Development Review Committee
Staff Report
Feb. 17, 2016

Case No:	16DEVPLAN1006
Request:	Community Facility Review
Project Name:	Clifton Heights CSO Storage Basin
Location:	1827 Drescher Bridge Ave.
Owner:	Louisville/Jefferson County Metro Government
Applicant:	Meskerem Eshetu - MSD
Representative:	Meskerem Eshetu - MSD
Jurisdiction:	Louisville Metro
Council District:	9 – Bill Hollander
Case Manager:	Ross Allen, Planner I

2. Aerial Photograph

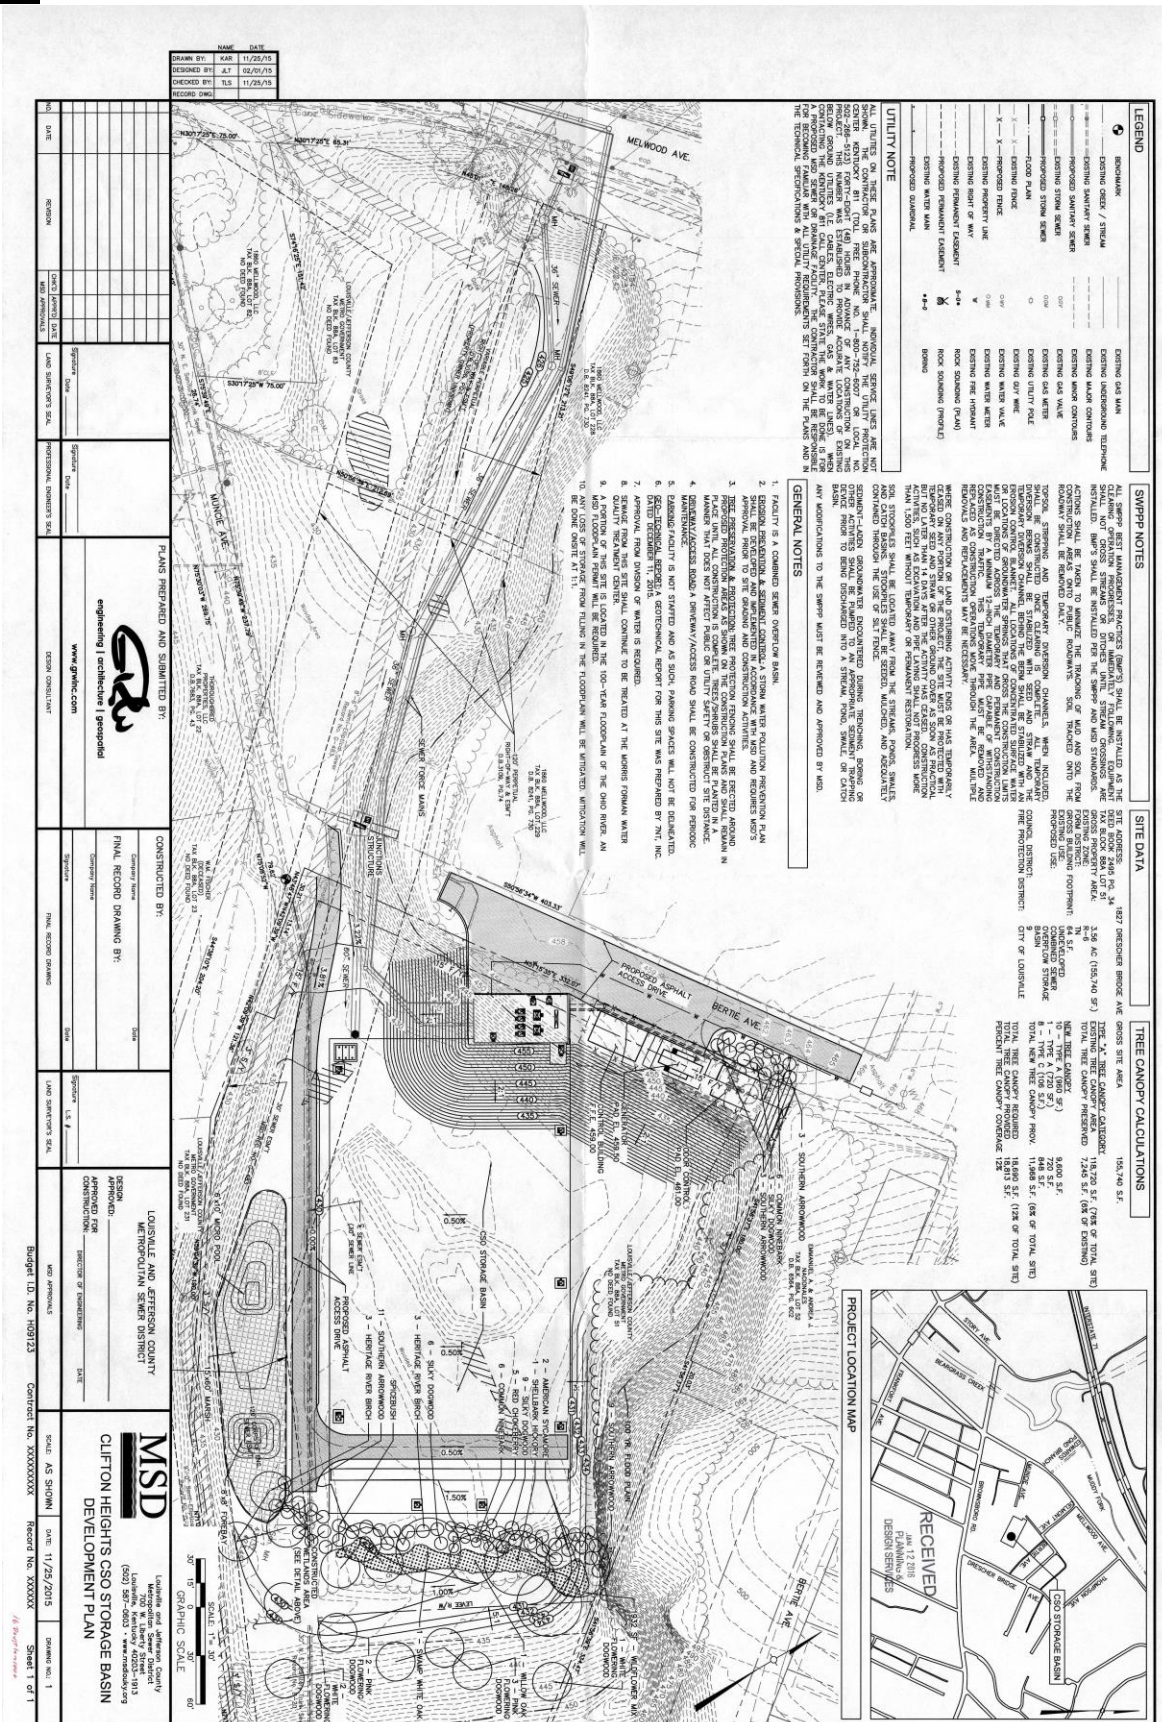
1. The applicant should explain how the non-residential expansion into a residential area could potentially impact residences in the general vicinity (see aerial map page 5).
